CHUCKANUT VILLAGE MARSH
Parking Area
1"=30'
OWNER AND ADDRESS
City of Bellingham
210 Lottie Street
Bellingham, WA 98225

PROPOSED: Culvert removal and beach restoration
IN: Chuckanut Bay
COUNTY: Whatcom **STATE:** WA
APPLICATION BY: City of Bellingham

Sheet 6 of 9

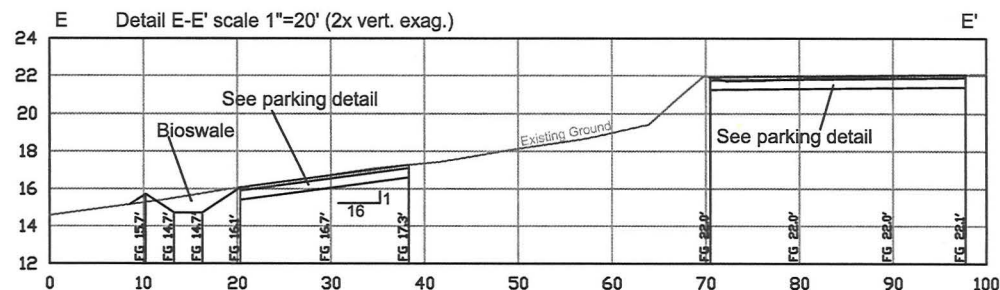
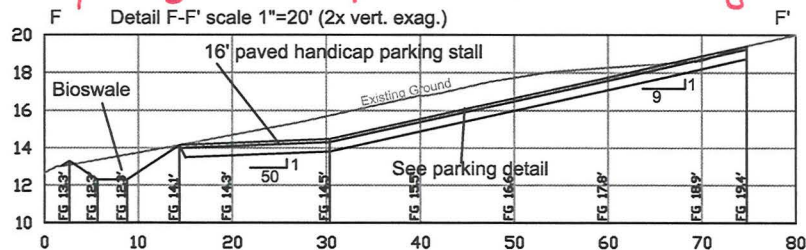
Approx. location of two parallel parking spaces. Each space is approx. 22 ft by 8 ft.

Hydrant to be relocated.

Privacy hedge to be expanded to 44 ft. Long.

Revisions not to Scale.
